Re: **Santa Fe ⁴ at the Trails Unit II Grading and Drainage Plan**
Engineer's Stamp dated 7-12-06 (C9/D1B)
15

Re: Tierra Vista Units 1 and 2 at the Trails, south of Woodmont and east of Pond H,
Grading and Drainage Plan (C9/D001F)

**Re: Tierra Vista Units 1 and 2 at the Trails, south of Woodmont east of Pond H,
Grading and Drainage Plan**

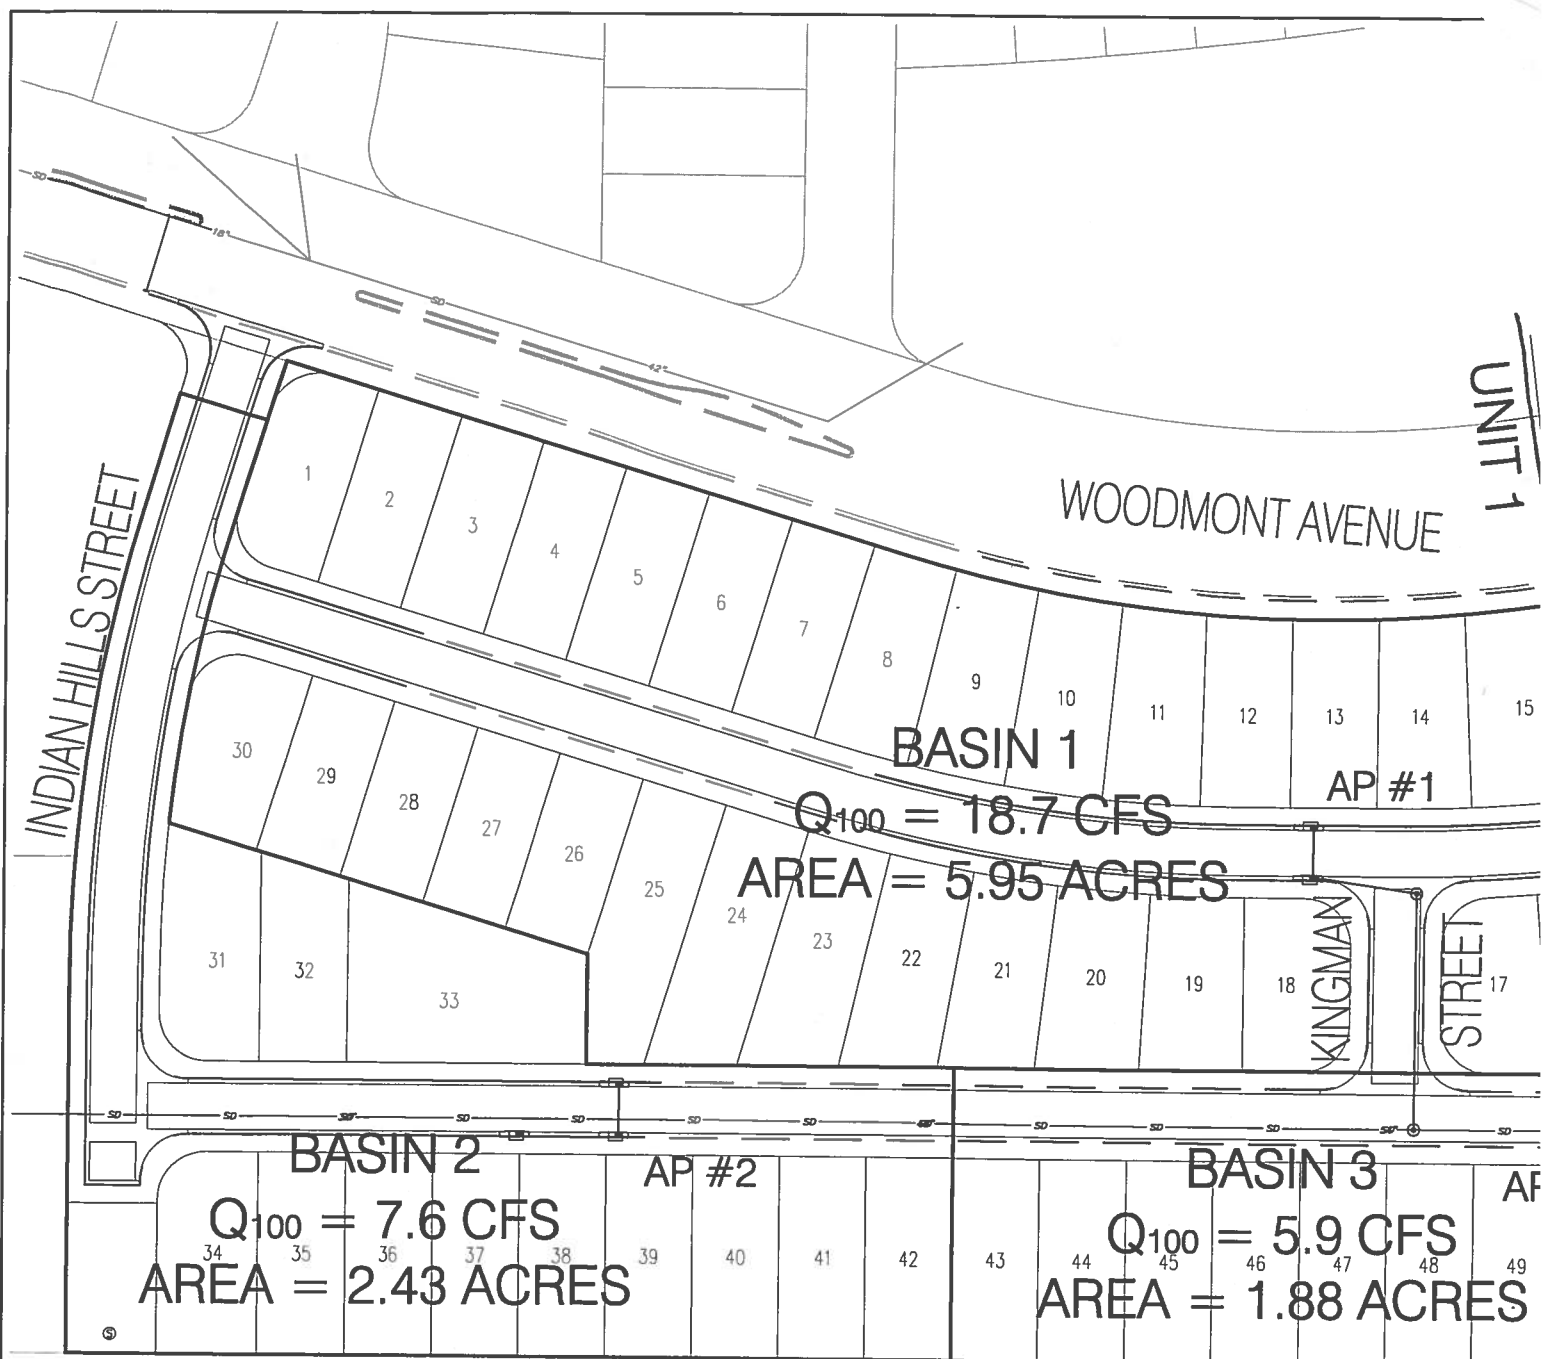
everything drain to K

address land treatment in 3 ssk per basin to
determine the size of pond K

is K detention or retention
